RE: Submission of Legal Counsel Comments Regarding Upton Apartments 40B Application

RE: Initial Review of 40B Application – 47 Main Street

Figure 1 – Plan Sheet C-4.0

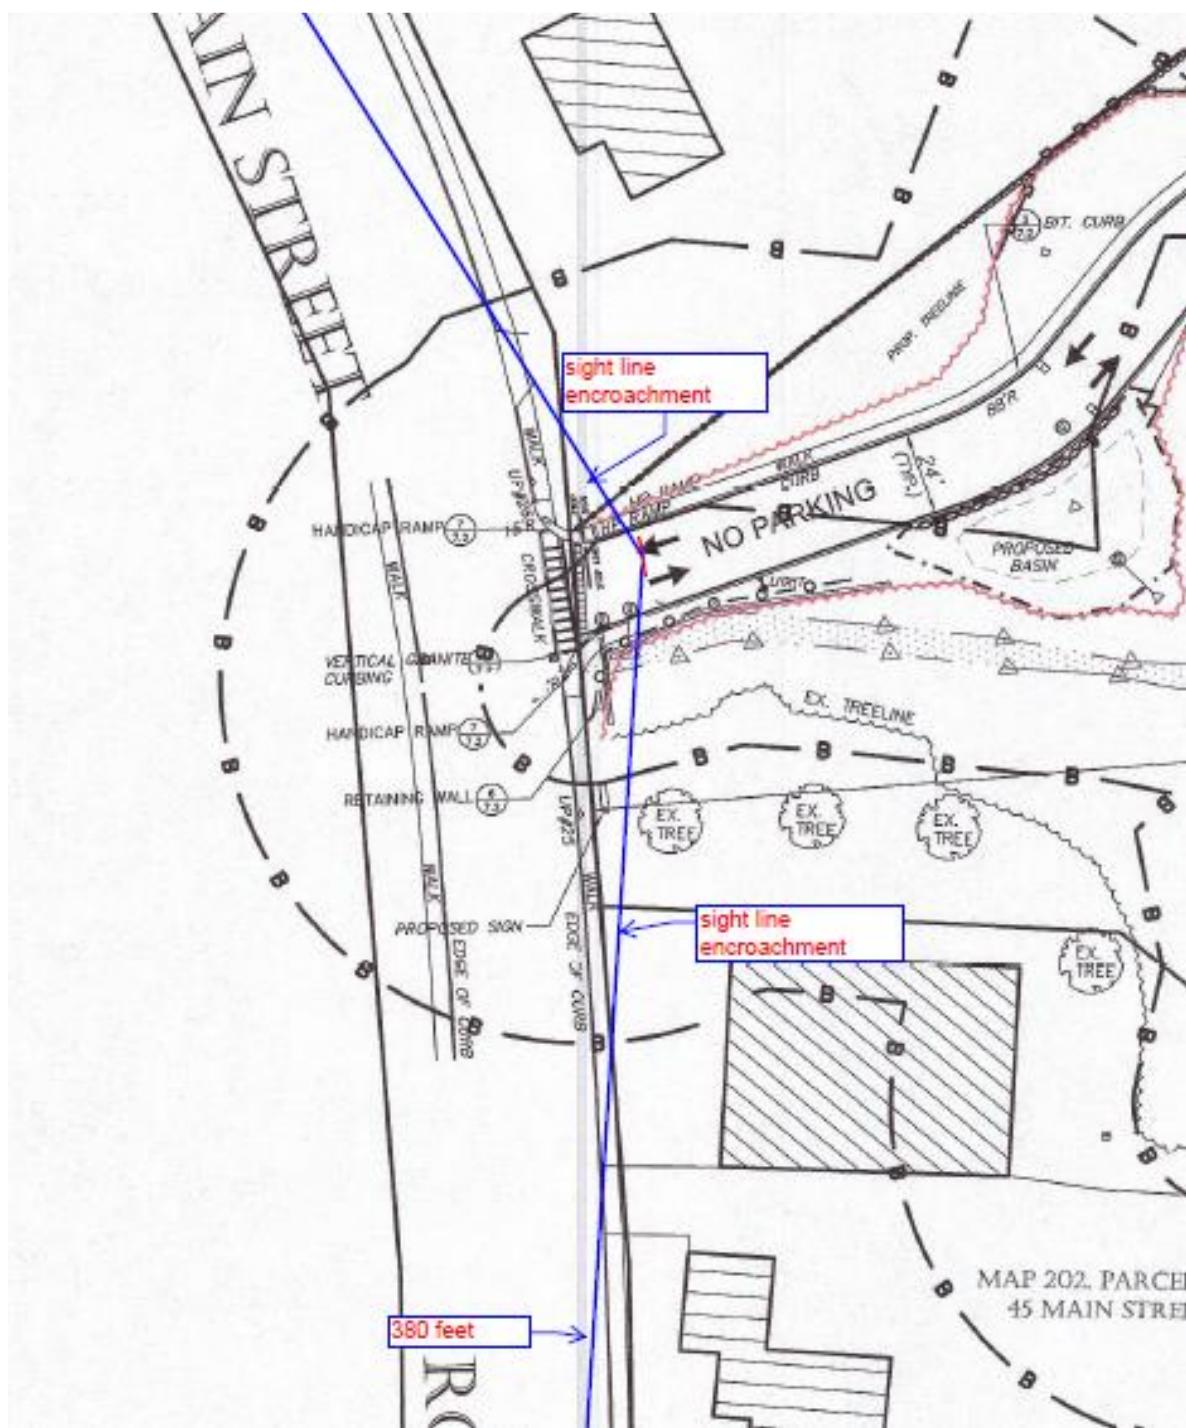
- d. I did not see a roadway profile plan for Project driveway, which is a typical component of a plan set. The grade (slope) of the sidewalk running along the driveway appears to be exceed 6% in some locations (i.e., 338' to 344'), which exceeds the state Architectural Access Board standard of 5%. Accessible routes that exceed 5% are considered "ramps," and appropriate accommodations must be made. I did not see any details of this sidewalk or ramps in the plan set.

Figure 2 - Architectural Plan 9/7/23

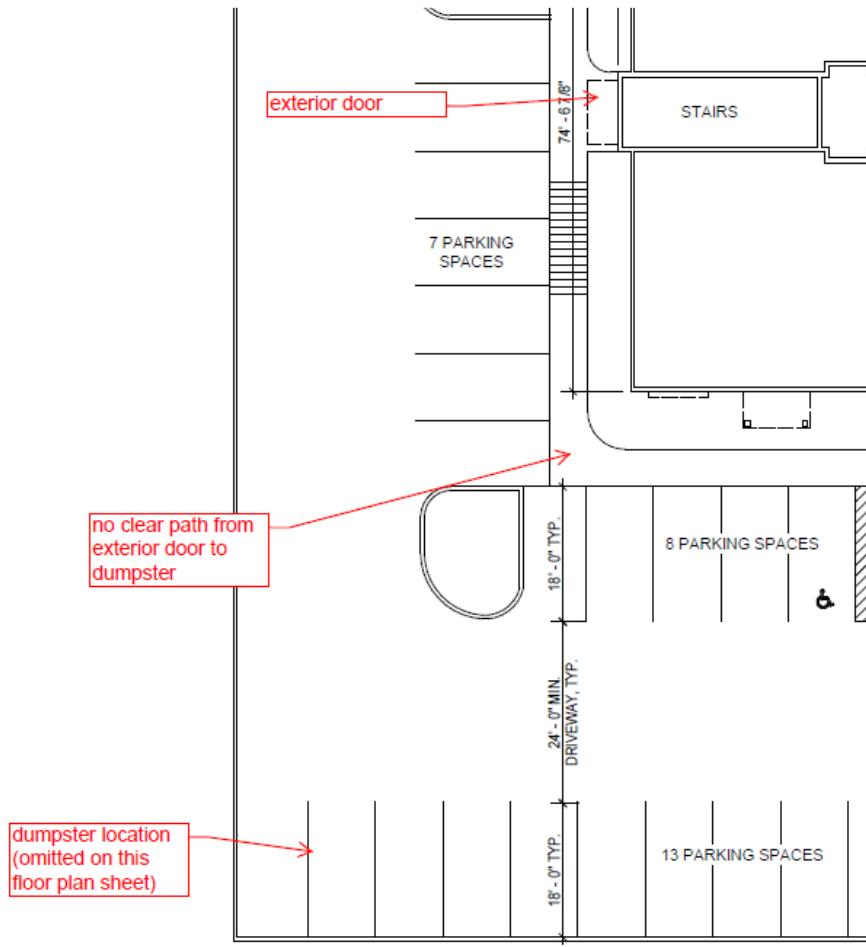
- c. It is not clear whether one of the two dumpsters would be reserved for recycling.
- d. There is no walking path from the side exterior door on the ground level to the rear dumpster – if there parking lot is full of cars, you would have to walk with your trash bags between parked cars. See Figure 2 below.

Figure 3 – Architectural Plan 9/7/23

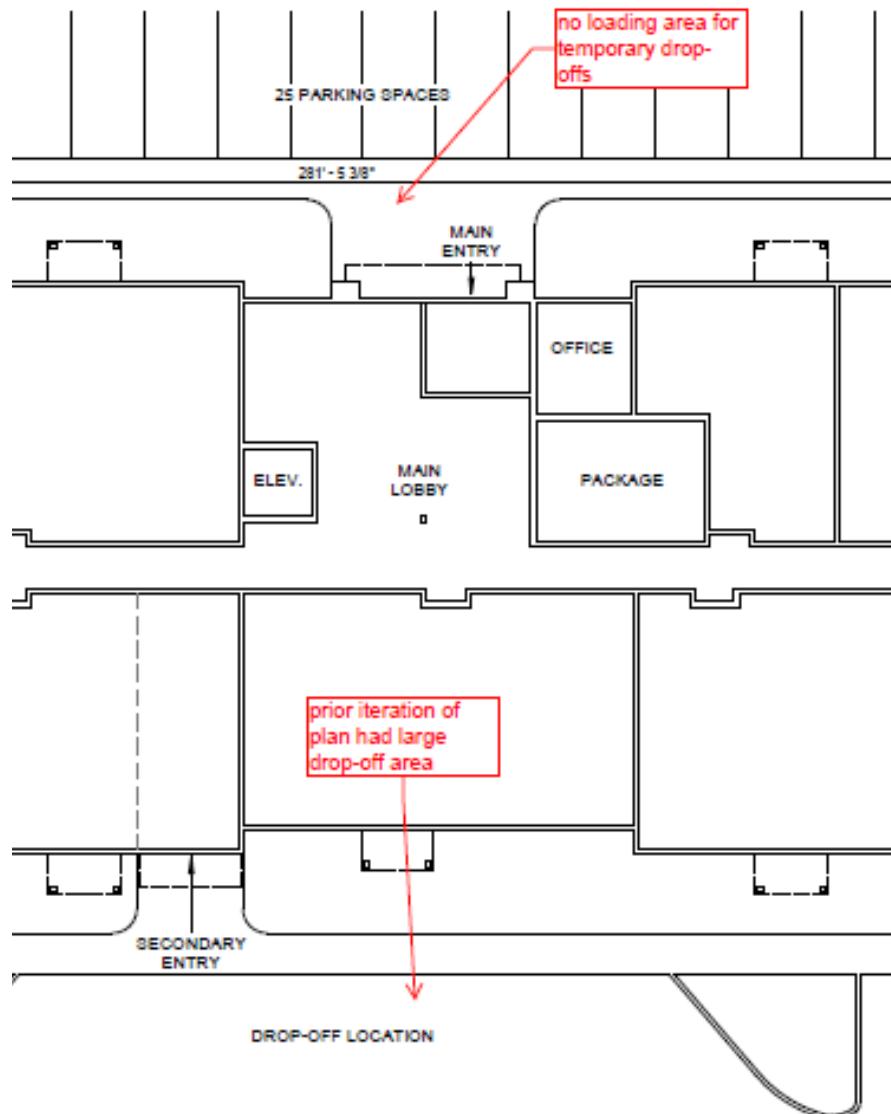
- b. There is no dedicated loading area for temporary vehicle trips, such as drop-offs (e.g., Uber), delivery vehicles, moving trucks, etc. These types of temporary or transient trips are more common in this type of residential setting. Moving trucks will be a regular occurrence because this is a rental property. There does not appear to be any thought or planning into moving day logistics. A moving truck would necessarily block a driveway while loading/unloading. See Figure 3 below.

Figure 4 – Plan Sheet C-4.0

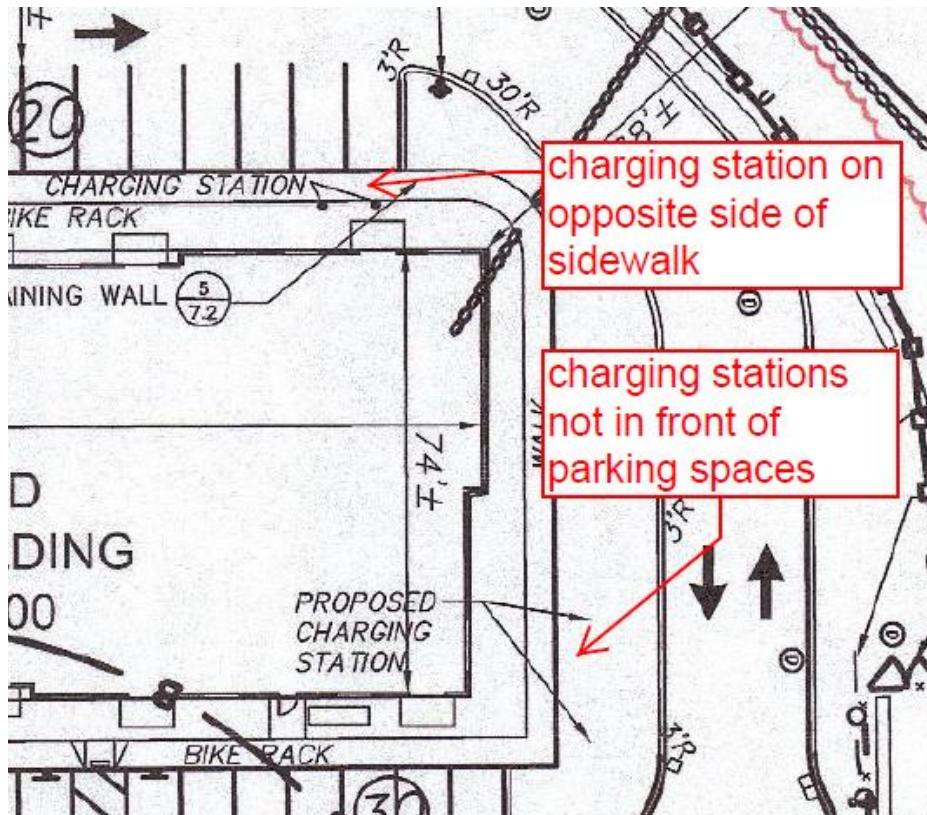
- d. Two EV charging stations are apparently proposed on the northerly side of the building. This is not practical, as there is no parking spaces on that side of the building. A charging station needs to be located in front of a parking space. Two charging stations are proposed near parking spaces on the west side of the building, but they are shown on the far side of the sidewalk opposite the parking spaces, which is also not practical. A charging station has a cord to connect to the car, and this cord would block the sidewalk, even if it were long enough. Suggest that the Applicant visit a parking lot with charging stations to better understand how these work. See Figure 4 below.
